Applicant's A.22(2A)(b) Response Statement to Louth County Council LRD014 Notice of Opinion

Old Slane Road, Drogheda, Co.Louth

Prepared on behalf of
Lagan Homes Tullyallen Ltd

Figure 1: Boundary Treatments in the south west corner of the application site

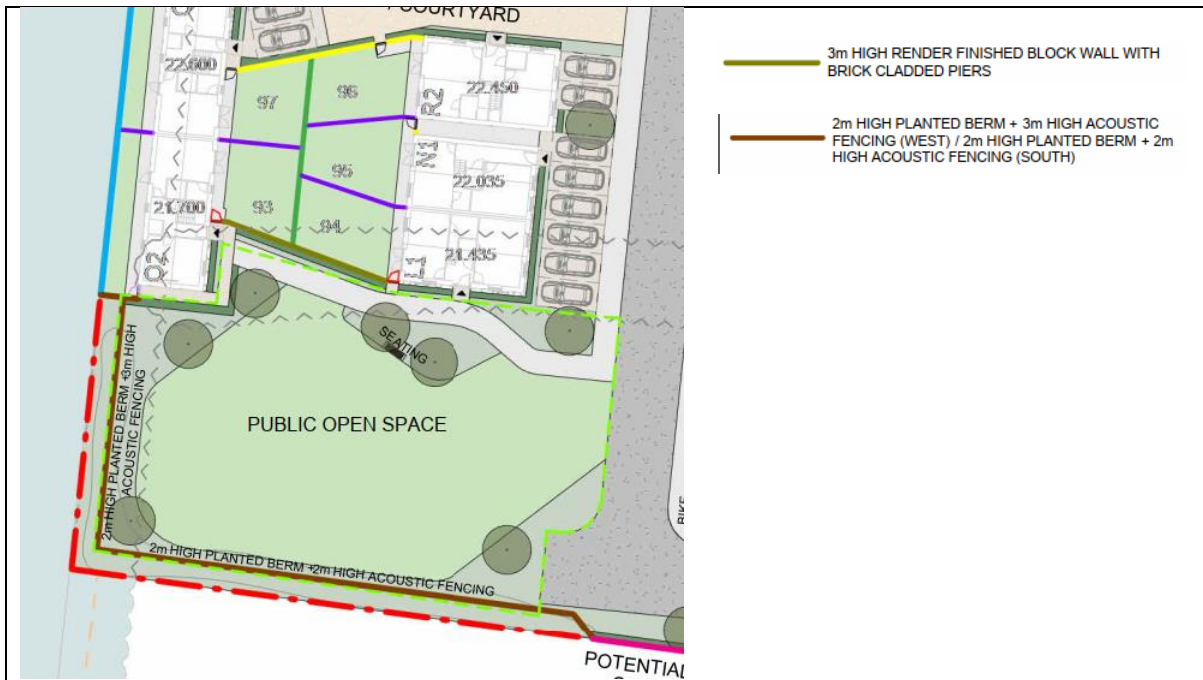
The prospective applicant is recommended to investigate additional noise reduction measures on site to take account of those areas where the external noise level exceeds the 55dB LAeq 16 hours threshold. The prospective applicant is also recommended to investigate additional noise reduction measures factoring in expected future noise level increases of 1-2dB over the next 10 years.

The applicant has undertaken an iterative design process with advice and analysis by Amplitude Acoustics to investigate additional noise reduction measures for the area at the south west corner of the site that exceeded the external noise level of 55dB LAeq 16 hours. The assessment provided under separate cover includes for the 10-year forecast increase in traffic volume and associated increase in noise levels outlined in the TII document Project Appraisal Guidelines Unit 5.3 'Travel Demand Projections'. The revised assessment continues to demonstrate an improvement across the site in terms of noise intrusion.

Based on the results of the assessment, the boundary treatment at the south west corner has been increased in height. As detailed at Table 9 of the report by Amplitude Acoustics and the landscape general arrangement plan, a 2-metre high berm and 3-metre high acoustic fence is proposed along the eastern boundary of the public open space in this location. In order to ensure the private gardens of house Nos. 93 and 94 achieve noise levels below 55dB LAeq 16 hours, a 3-metre boundary wall is proposed along the south of these plots. As illustrated by figures 2 and 3 below, even with the expected increase in future road noise over the next 10 years, all garden areas are protected from noise intrusion.

There are areas of public open space that exceeds 55dB LAeq 16 hours. Guidance on noise levels for external amenity areas is provided by BS 8233:2014 and ProPG 2017. ProPG 2017 refers to the BS8233:2014 guidance which states that while noise levels should ideally not be above the range 50-55dB LAeq,16hr, "*These guideline values may not be achievable in all circumstances where development might be desirable. In such a situation, development should be designed to achieve the lowest practicable noise levels in these external amenity spaces but should not be prohibited.*" Every effort has been made to reduce noise intrusion into the site to the lowest practicable external noise level. Even with the expected increase in future road noise over the next 10 years, the results demonstrate an improvement over the development as permitted.

Figure 4: Extract from Waterman Moylan Drawing No. 3103

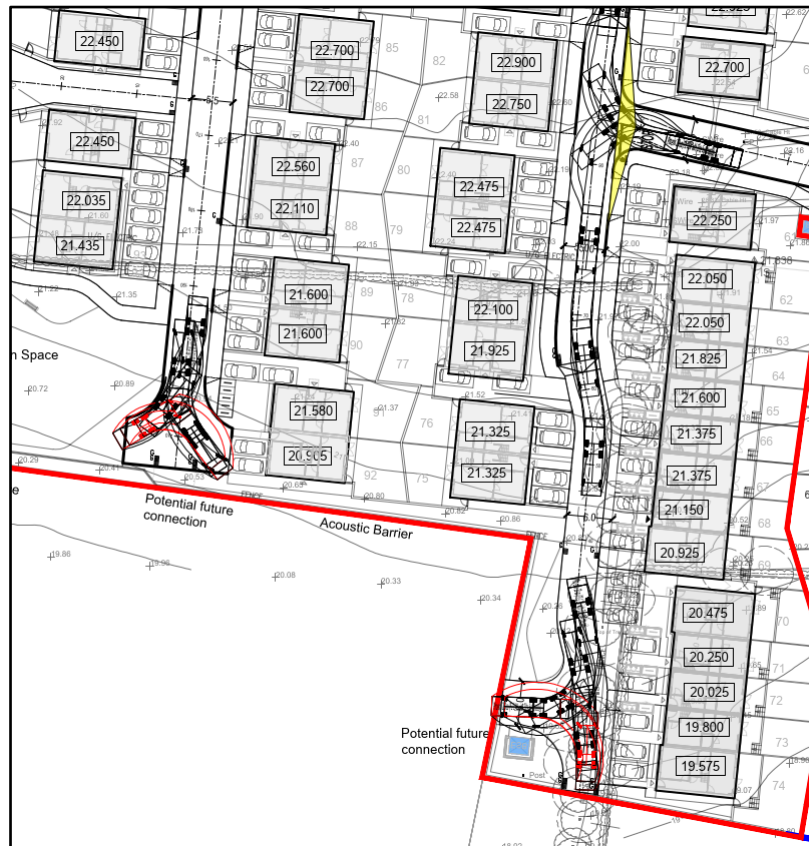
7. *Turning bays shall be incorporated to avoid long reversing movements by large vehicles. Turning bay opposite house number 74 shall be in accordance with Recommendations for Site Development Works for Housing Areas figure 2.2 type (ii) Published by the Department of Environment.*

The site layout plan has been updated to take account of the Opinion. The number of cul-de-sacs has been minimised with only two turning bays required for large vehicles. Swept path analysis drawings demonstrate that a refuse vehicle can adequately manoeuvre throughout the site.
